Response to RBC Planning Officer Comments

Condition 9 (EV Charging Points)

- **EV Parking Strategy locations (RBC-WLR_HTA-A_XX_00_DR_0132 - Rev. B)**

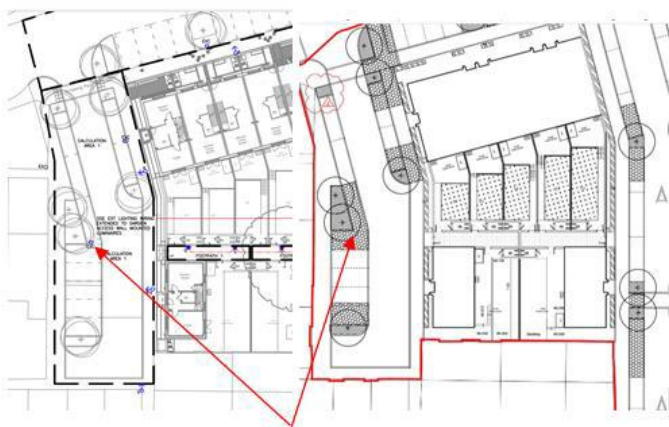
The proposed drawing illustrates 2 EV charging locations in calculation area 1 (north-west corner of the site) that are not highlighted blue but may still create confusion. I would suggest that reference to these is removed from the drawing but I would not object to the discharge of condition should these be retained.

The applicant has confirmed that the 2 EV charging locations in calculation area 1 (northwest corner of the site) will not be provided. This was a graphical error on the previously submitted drawing.

Please find attached revised drawings that remove these highlighted areas from the plan and address the comments noted above. Revised Drawing:

2131-NBP-XX-XX-GA-E-140 C20 Sheet 1 of 3)

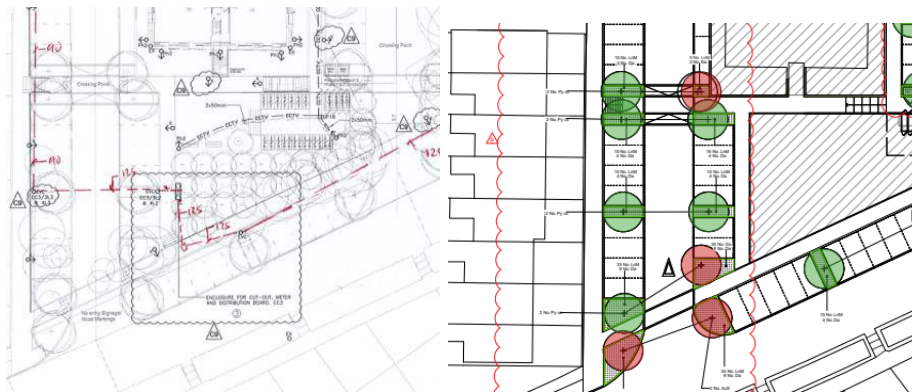
My previous memo highlighted one particular location (as below) in relation to the conflict with root cells and queried why all e-duct routes were not shown.

In relation to the location shown above, as included on 2131-NBP-XX-XX-GA-E-140 C20, I note the particular EV charging point has been omitted, which I assume is acceptable with Transport. However, the drawing still has text stating 'electric car charging points' in this car park area when none are shown, which is confusing and which should be removed if none are proposed.

Regarding the EV charging located to the north-west of the site, as noted in the response to the Transport consultant, the EV charging for this location has been removed, eliminating any potential conflict with the root cells in this area. We have submitted a clear drawing showing the provided EV charging locations to clarify the positioning of both the EV spaces and tree locations. Revised Drawing:
